### **ROAD SAFETY AUDIT STAGE 2** **January 2023**

Proposed diversion of existing footway and  
provision of additional on-street parking.  
Bowers Place, Crawley Down, West Sussex RH10 4HY

Document Ref: J1481-RSA-2-1

## APPENDIX B – Reference plan

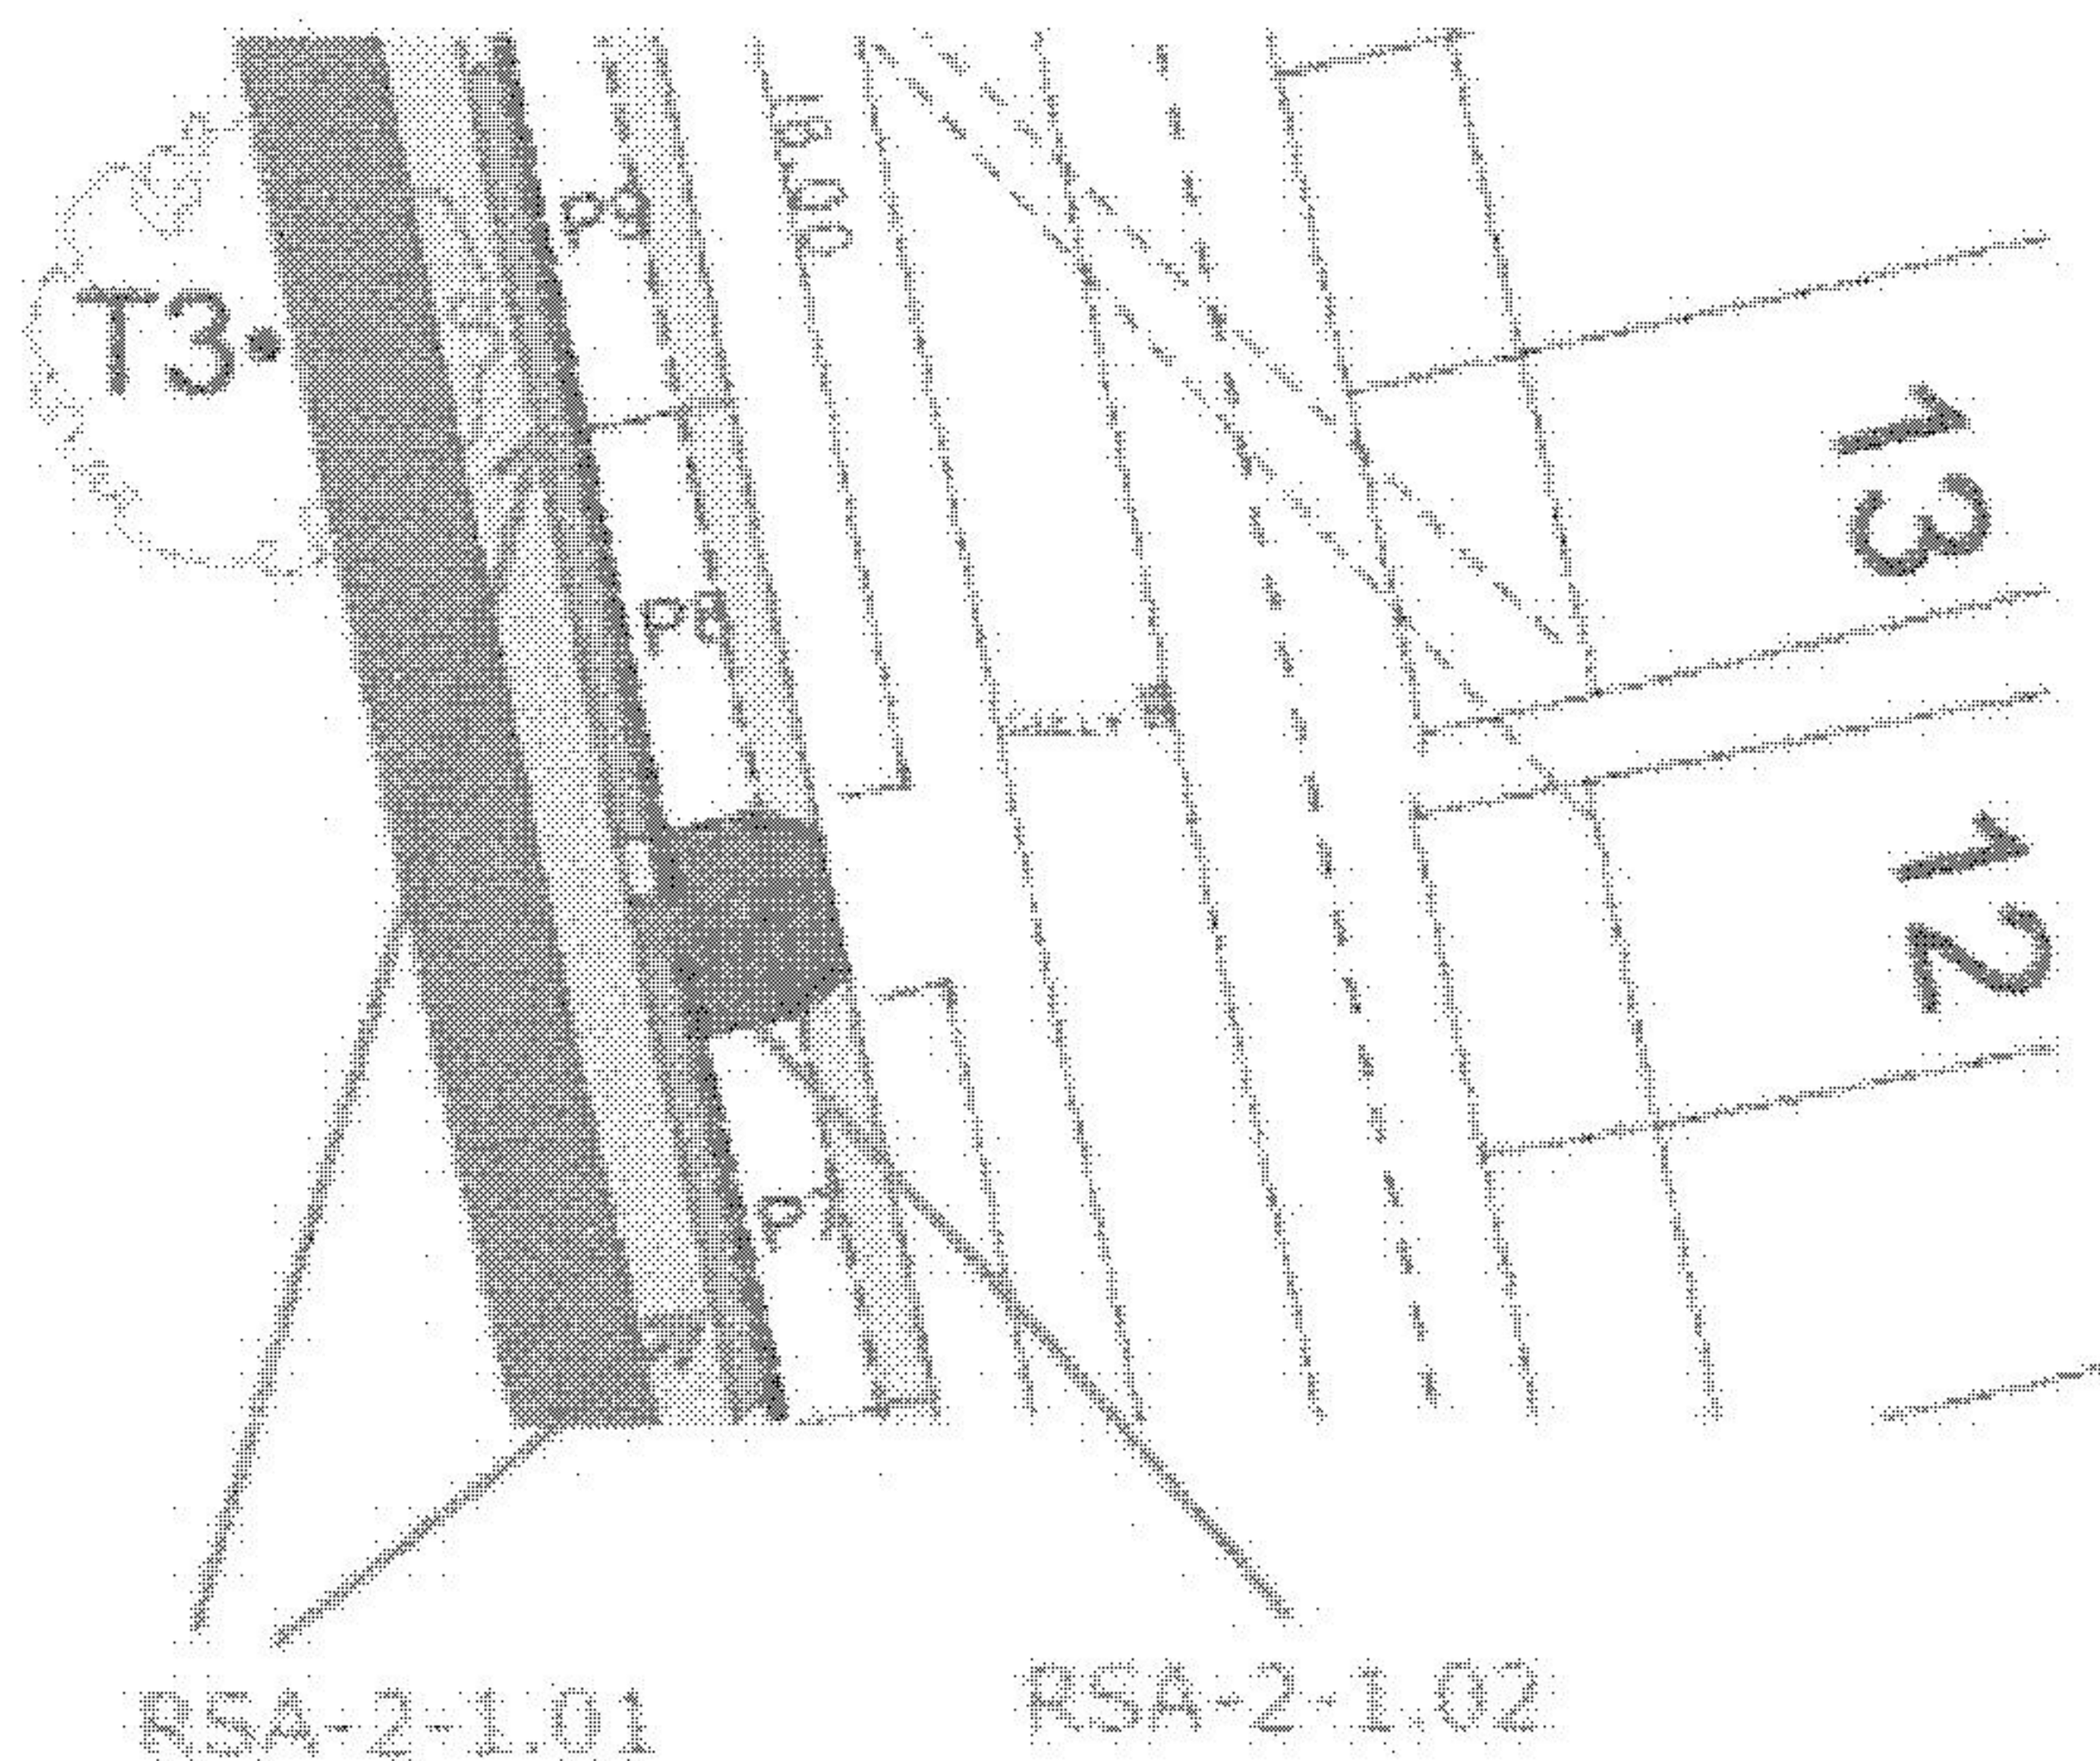
**RSA-2-1.01.** Issue: Slips and falls.

Location: Length of proposed new parking area.

Summary: The design shows the retention of a grass strip between the new parking area and the proposed non-dig path. The proposed strip will be approximately 600mm wide with a nominal rise of 175mm. Vehicle occupants will either need to cross the strip or negotiate between parked vehicles to access the proposed crossing points to access the public space. Particularly in wet weather crossing the grass strip may lead to slips and injury particularly for pedestrians with mobility issues. The RSA 1 highlighted this issue, and the Designers Response indicated the strip was necessary to maintain access to electrical cabling however, it appears that the majority of electrical cabling is overhead.

Recommendation: Review the design and confirm what cabling lies within the proposed grass strip area and remove the grass strip from the design.

**RSA-2-1.02.** Pedestrian conflict with street furniture.

Location: The proposed verge crossing point opposite no's 12 & 13.

Summary: The existing TP/EP pole and lamp column opposite 12 & 13 Bowers Place are not indicated on the drawing and it appears that the proposed crossing point will lead pedestrians, particularly those who are blind or partially sighted, into the existing lamp column resulting in injury.

Recommendation: Review the relative positions of the proposed crossing point and existing TP/EP and LC to ensure there is no conflict with pedestrians.
